# DECISION OF THE PLANNING COMMISSION

CLASS 3 DESIGN REVIEW / CLASS 3 SITE PLAN REVIEW / CLASS 2 ADJUSTMENT / CLASS 2 DRIVEWAY APPROACH PERMIT CASE NO. DR-SPR-ADJ-DAP17-01

**SUMMARY:** Proposed development of a 24-unit apartment complex, with an Adjustment request to reduce required interior setbacks.

LOCATION: 2758 Claxter Road NE

SITE PLAN LEGEND:	
BUE BUILDING		NEW MULTI-FAMILY BUILDINGS CLAXTER ROAD APARTMENTS 2758 CLAXTER ROAD NE SALEM, OREGON 97301
	^	sueet:

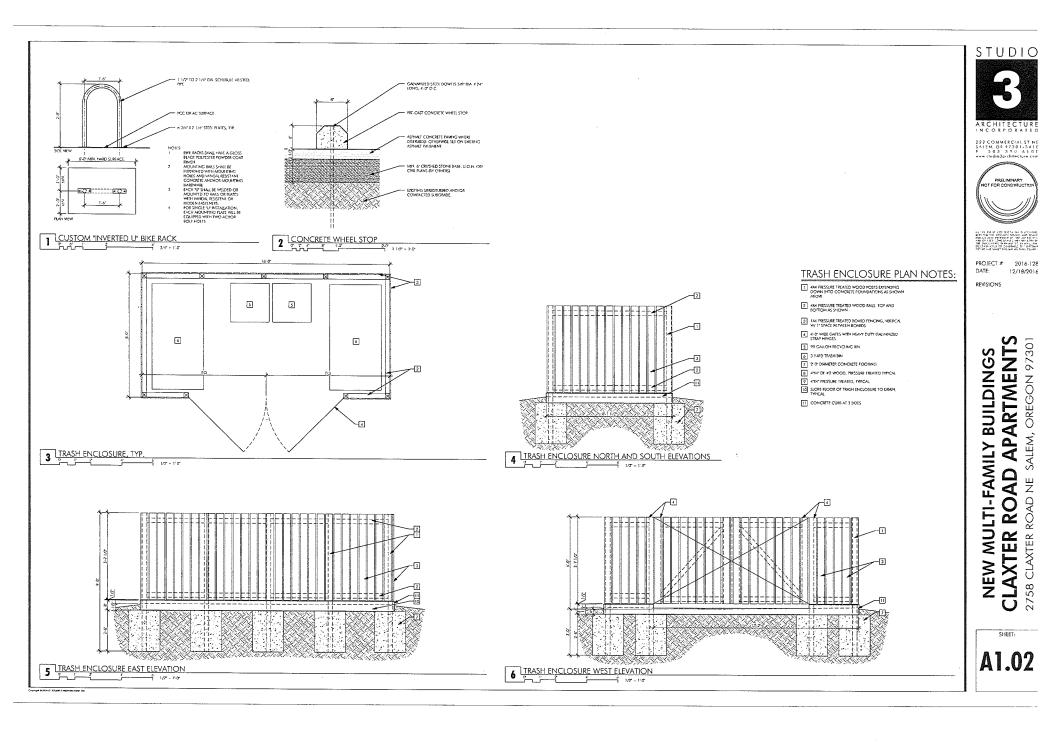
**Condition 1.** The front opening of the solid waste area enclosure shall be a minimum of 12 feet in width.

**Condition 5:** The adjusted perimeter setbacks, as approved in this zoning adjustment, shall only apply to the specific development proposal shown in the attached site plan. Any future development, beyond what is shown in the attached site plan, shall conform to the setback requirements for the development site, unless adjusted through a future land use action.

The Building and Safety Division reviewed the proposal and indicated that fire rated walls are required within 10 feet of a side or rear property line.

The Fire Department commented that fire lanes shall be marked on the building permit application plan set. The fire hydrant that is approximately 65-70 feet to the southeast on Claxter cannot be used for the Fire Department connection (FDC) as this would close the only access into the complex. Options include:

1) Relocate FDC to the SE side of the entrance into the complex, or

2) Install a fire hydrant NW of the entrance on the south side of the street. Fire may have other requirements at time plans are submitted for building permits, i.e. fire sprinklers, alarms, FD lock boxes.
